Amendments to the Drawings:

VERSION SHOWING AMENDMENTS

FIG. 4

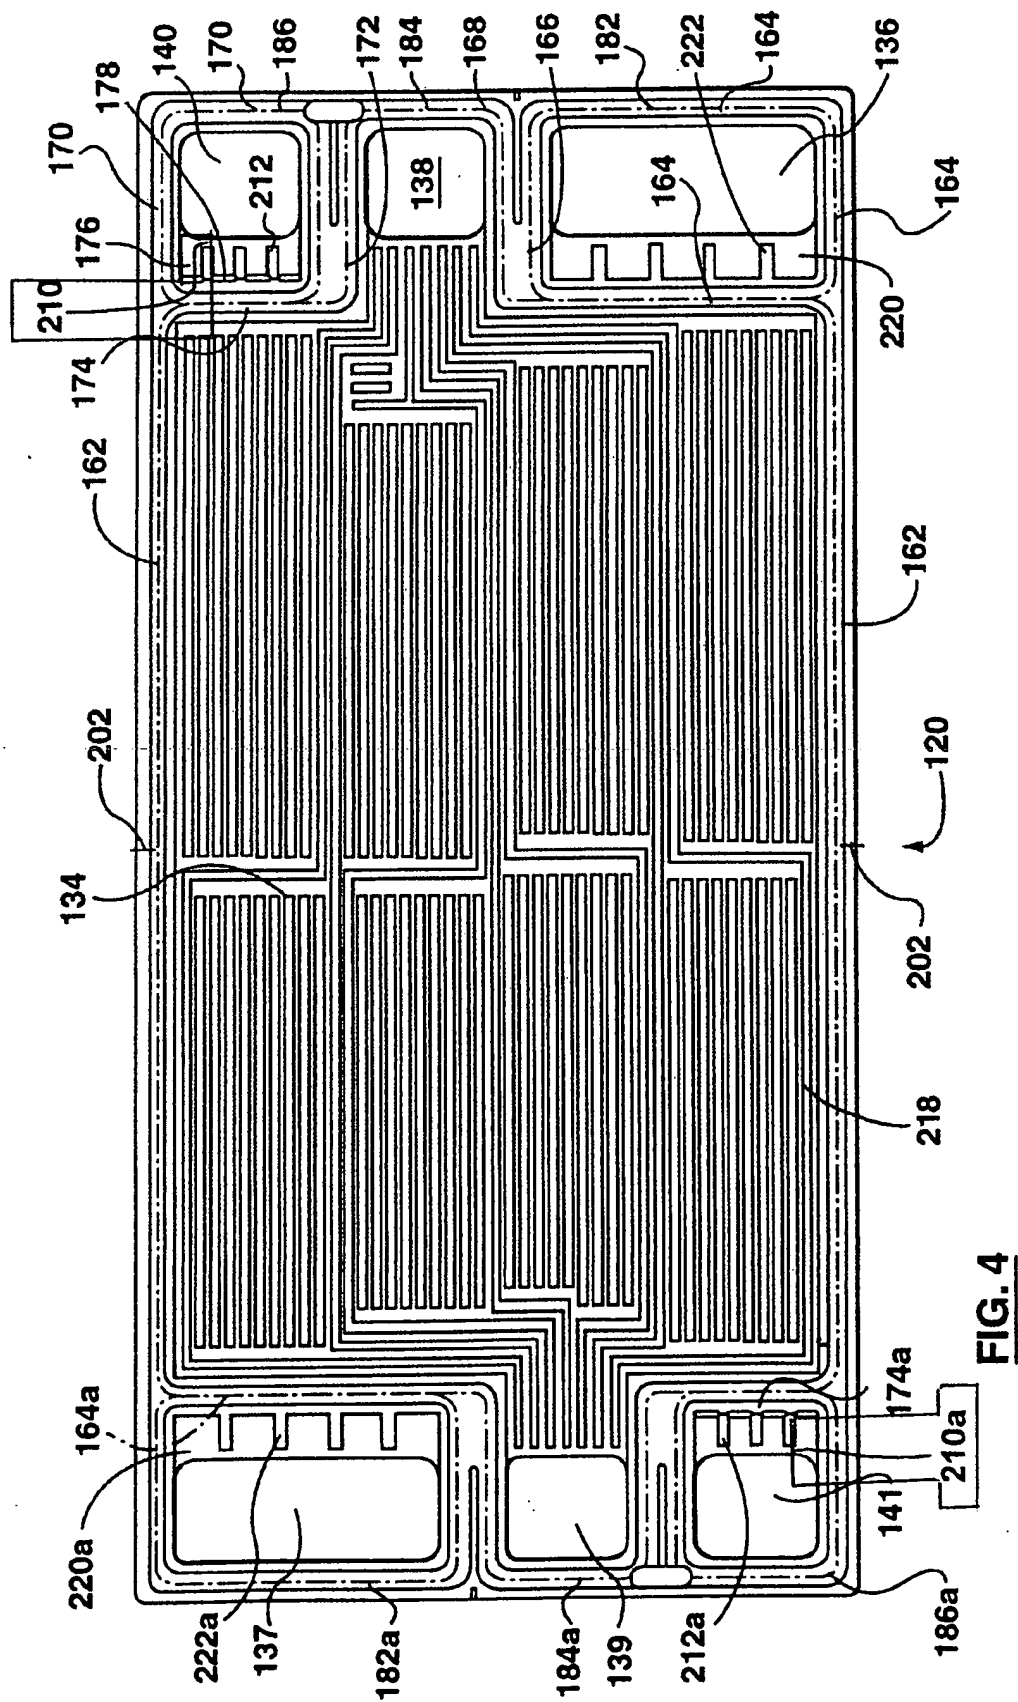
With regards to Figure 4, the leader line for label 210 has been changed to better describe the extension element associated with aperture 140. Also, the label 210a has been added with a leader line to indicate the extension element associated with aperture 141.
